Additions and Renovations
Platt Technical High School
Milford, CT

ADDENDUM NO. 3

August 2, 2019

RA3
2

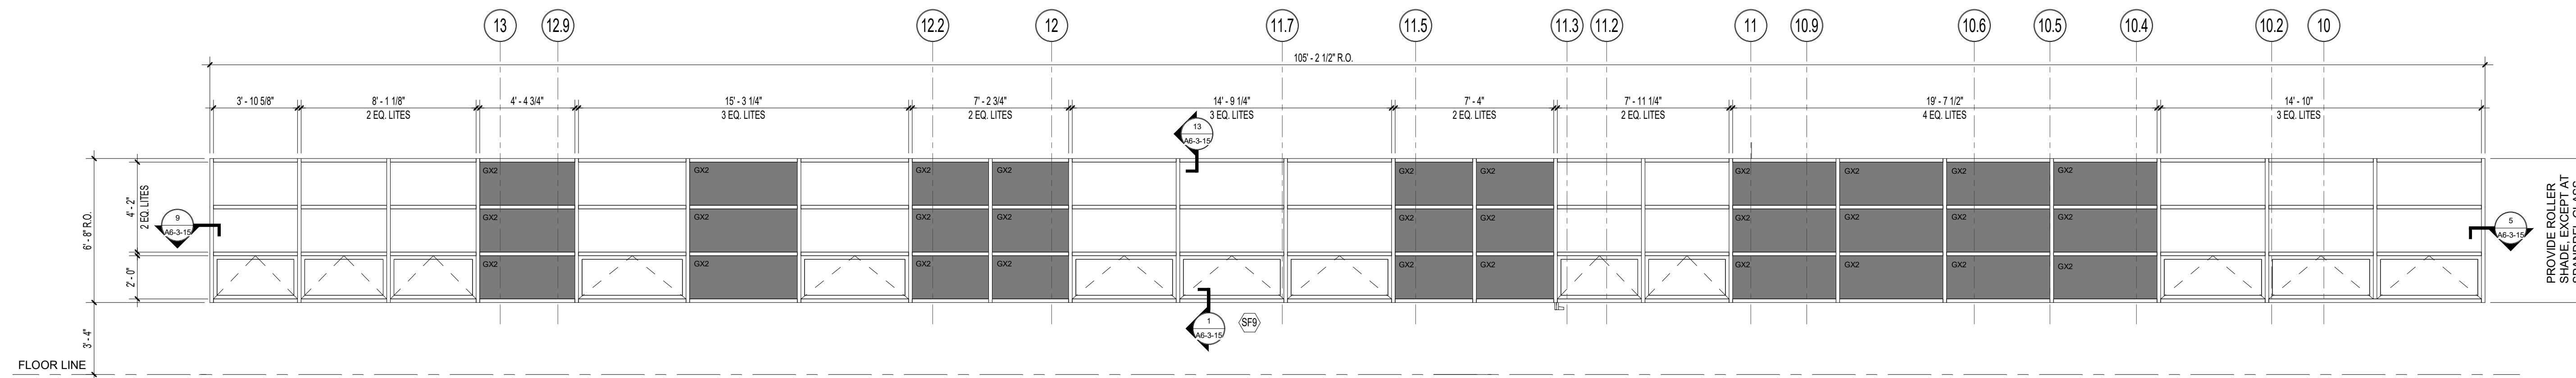
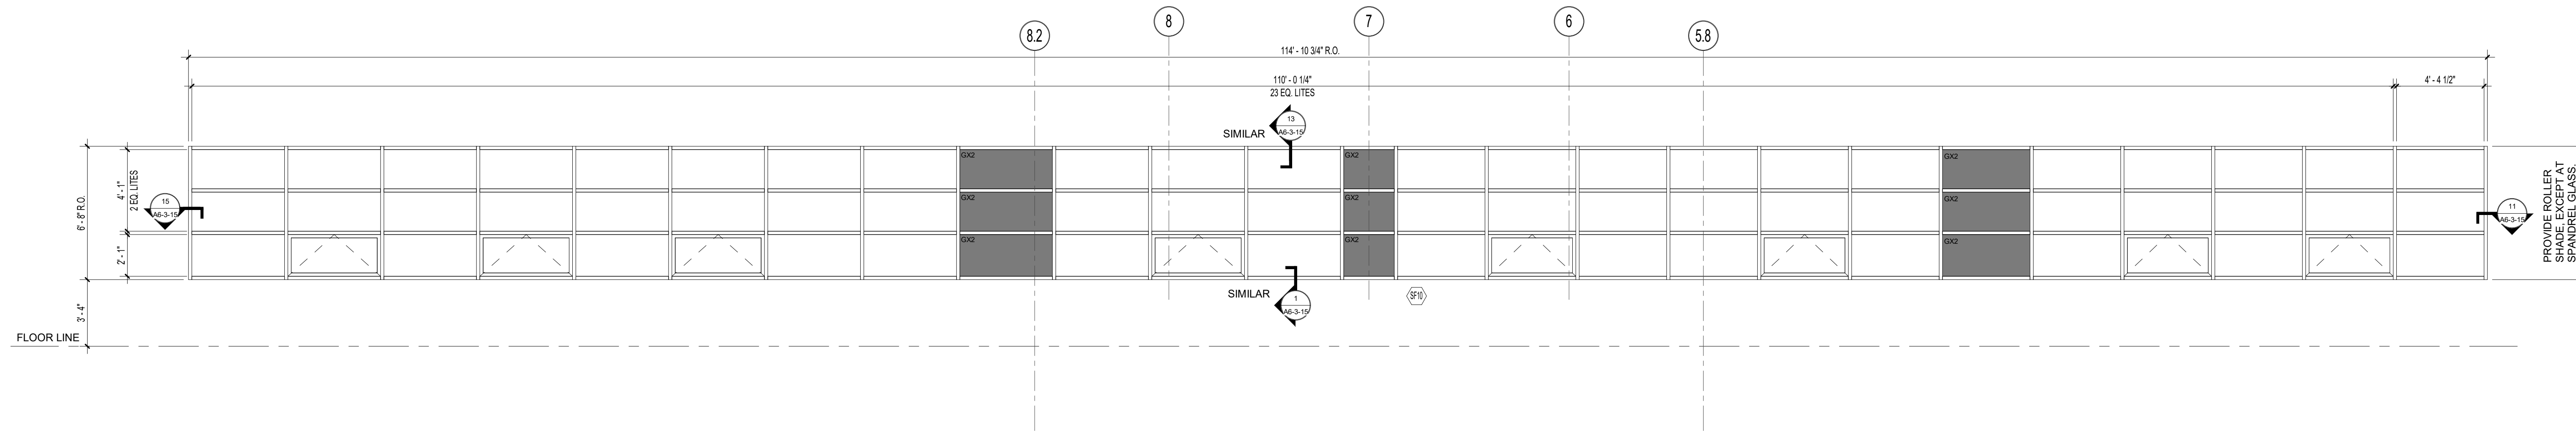
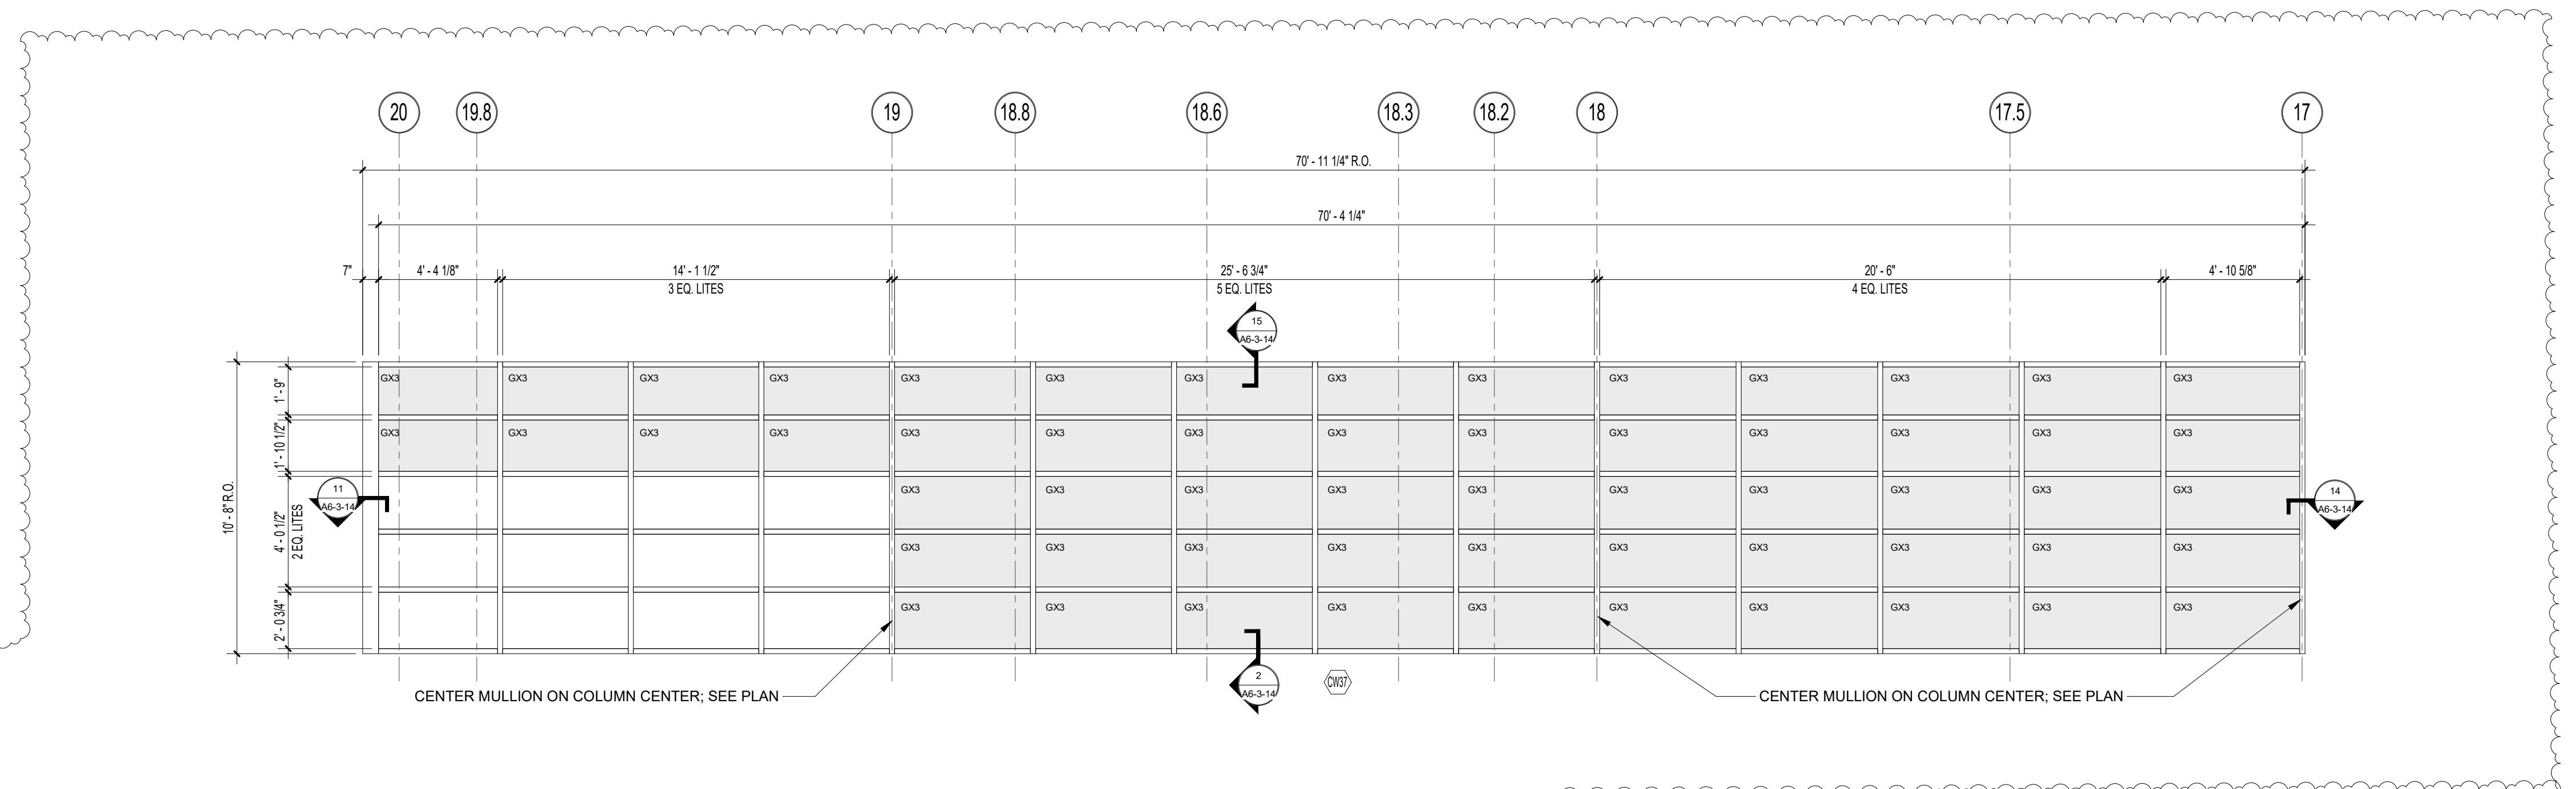
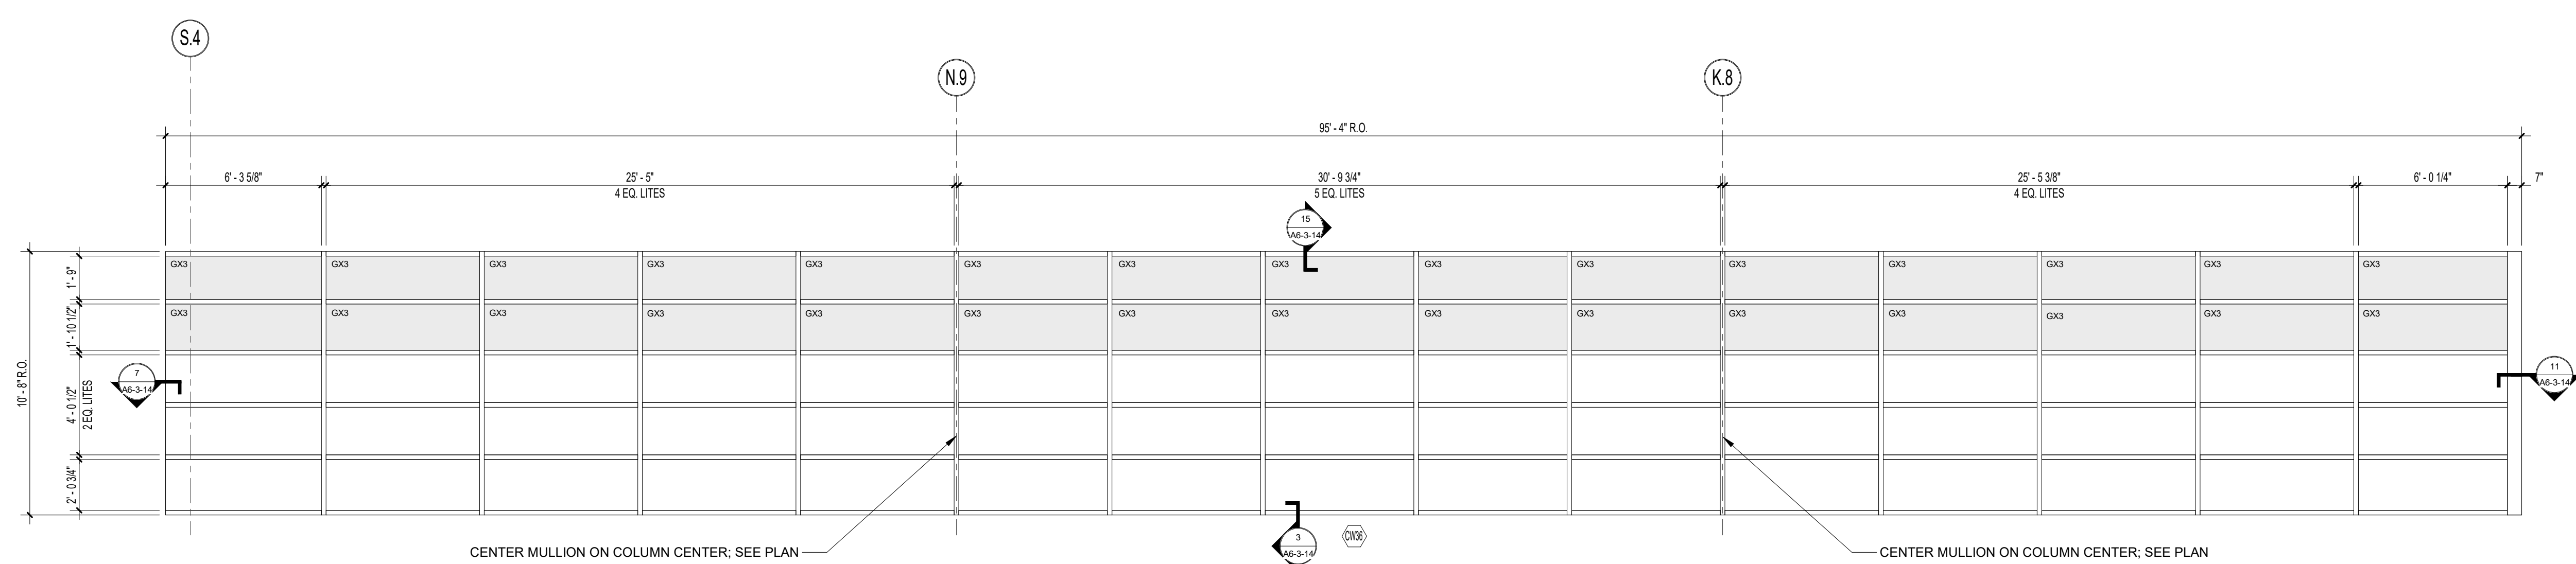
- ADD 3-064 DRAWING A6-3-5 – CURTAIN WALL AND STOREFRONT TYPES** (*previously titled Storefront Types*)
Revision RA3-2:
Frame Type CW36 (*previously SF7*): Revised frame type.
Frame Type CW37 (*previously SF8*): Revised frame type.
